BCA Assessment Report

Design Development Report
World Class End of Life Program
Tamworth Hospital

Prepared for:
Health Infrastructure

Revision 2
26 March 2025
Reference: N240096

Figure No. 42: Internal fire hose reel currently located > 4m from an exit

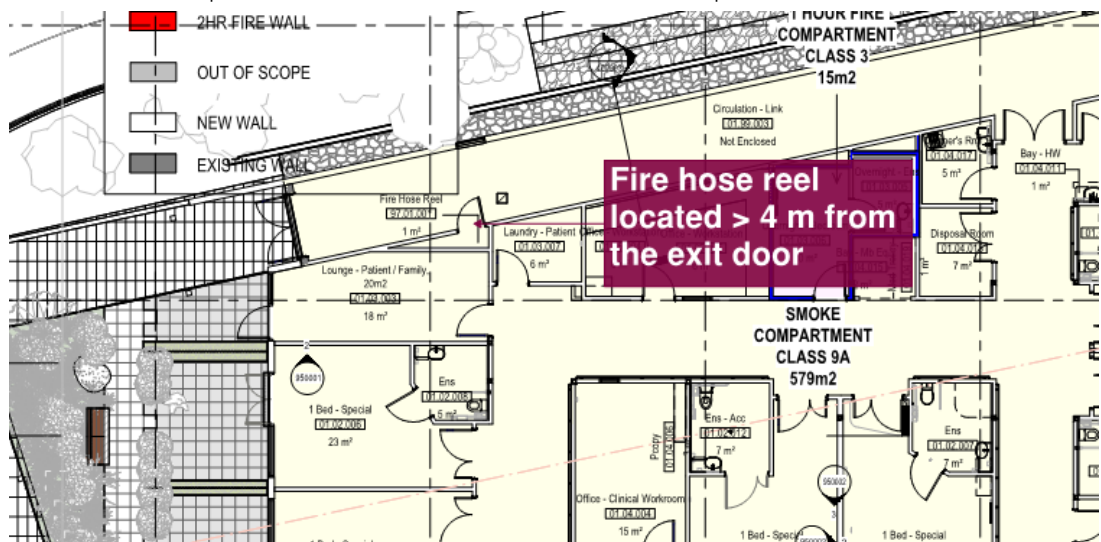
The fire hose reel will be required to be relocated to within 4 m of the exit, be installed adjacent to an internal fire hydrant or it will need to be determined by the Fire Safety Engineer whether the location of the fire hose reel can be subject of a Fire Engineering Assessment in order to demonstrate compliance with the nominated Performance Requirements of the BCA.

Figure No. 43: Confirmation required as to sprinkler coverage to covered walkways and covered entry

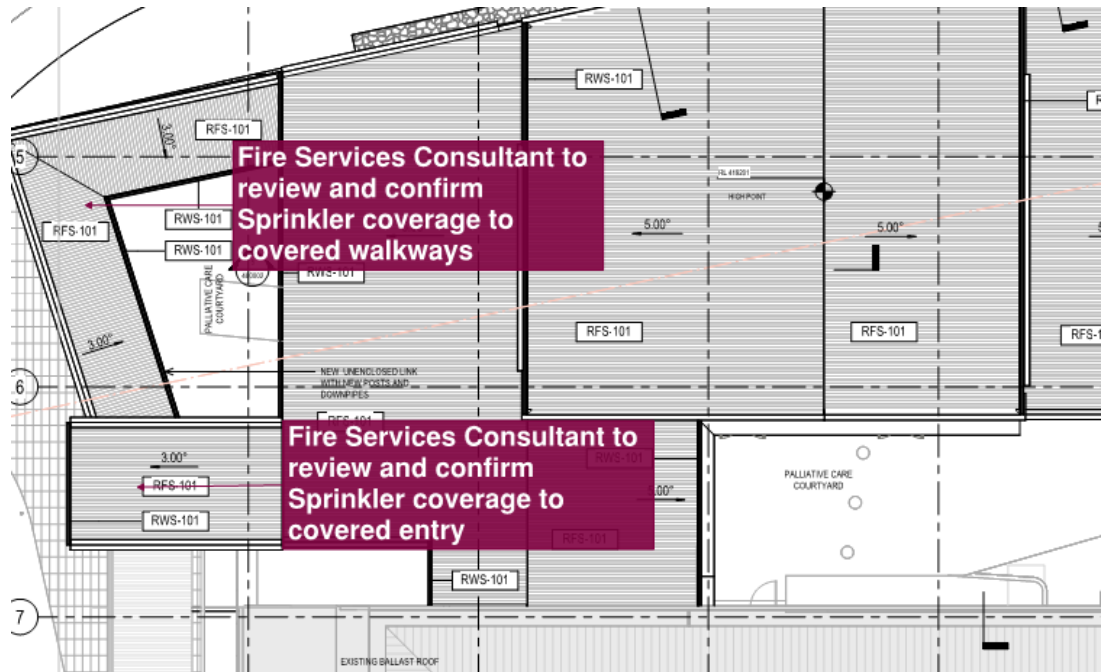
Verification from the Fire Services Consultant will be required as to whether the proposed unenclosed links are required to be provided sprinklers.

Figure No. 52: Proposed roof over the new entry to the Palliative Care extension within proximity to the existing ballast roof of the existing Acute Services Building

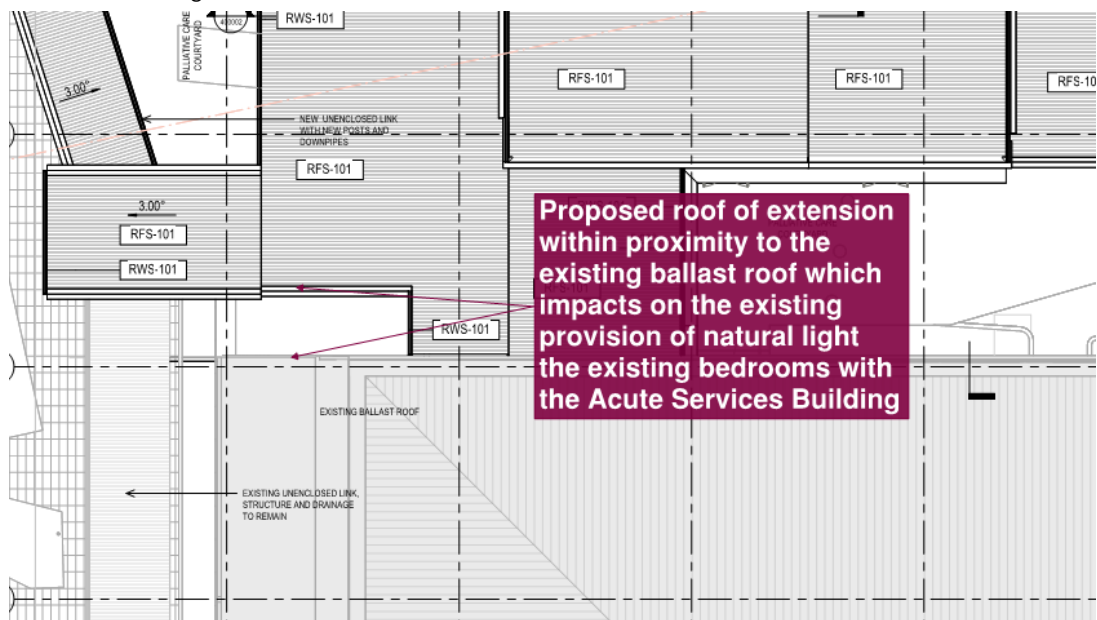
As a result of the proposed Palliative Care extension, there is a new roof structure associated with the entry to the Unit that is constructed in close proximity to the existing ballast roof as detailed in the figure below.
